ORIGINATION FORM

Proposed Revisions to a Standard Plans Index
(Please provide all information — Incomplete forms will be returned)

Index Number: 700-020

Index Title: Multi-Column Ground Sign

INDEX
700-020

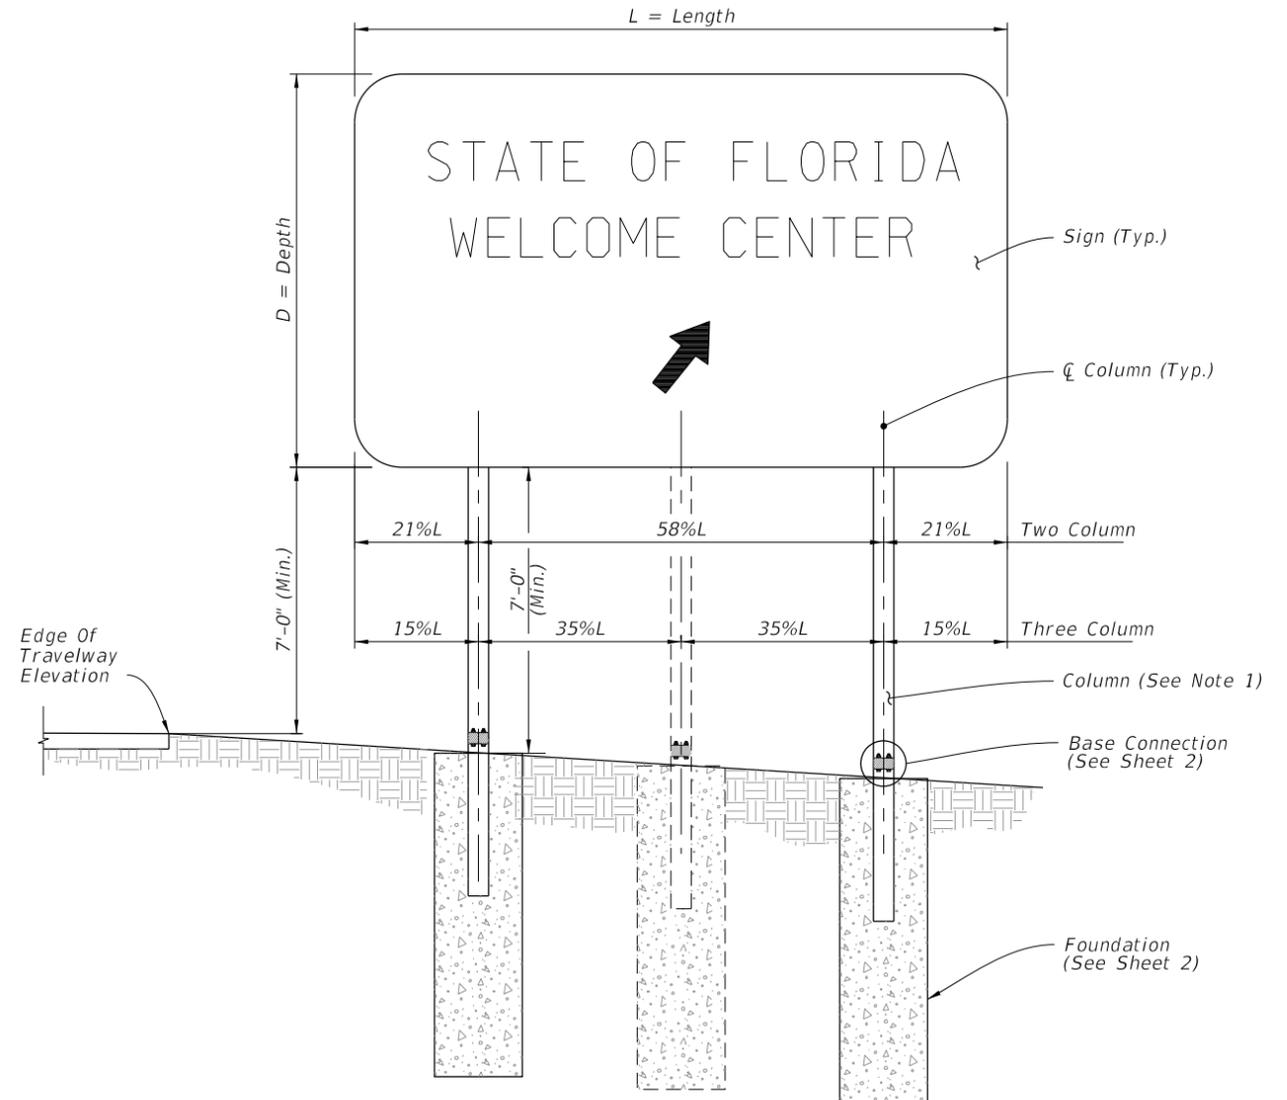
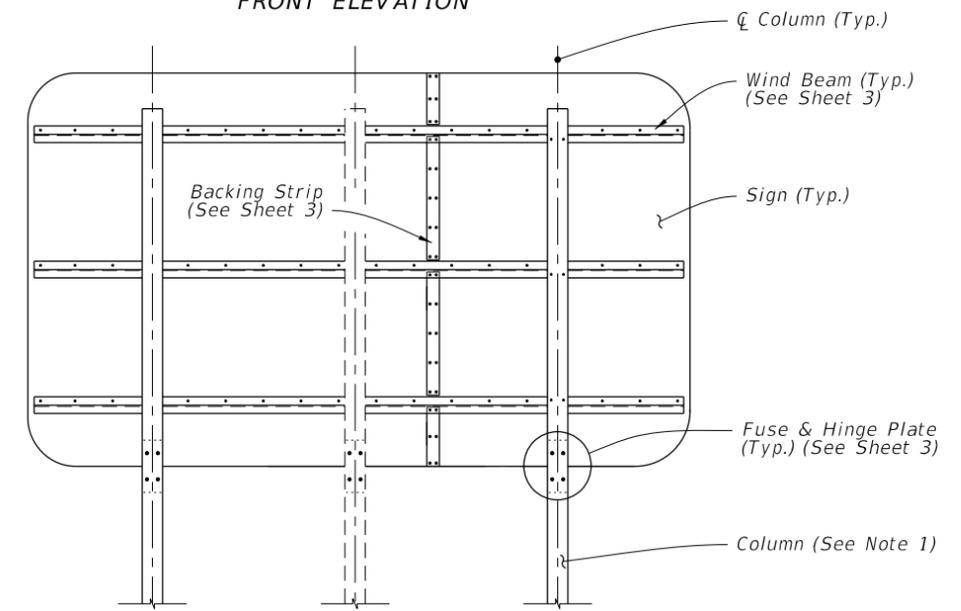
Sheet 1: Change Note 3.A.b reference to ASTM B308 to ASTM B221 throughout Standard Plans as an administrative change.

ASTM withdrew B308-10 so we need to change it to ASTM B221

- b. Aluminum Structural Shapes: ASTM B308, Alloy 6061-T6
 - B. Sign Support Structure Materials:
 - a. Steel Plates and Structural Shapes: ASTM A36 or ASTM A709, Grade 36

- b. Aluminum Structural Shapes: ASTM B221, Alloy 6061-T6
 - B. Sign Support Structure Materials:
 - a. Steel Plates and Structural Shapes: ASTM A36 or ASTM A709, Grade 36
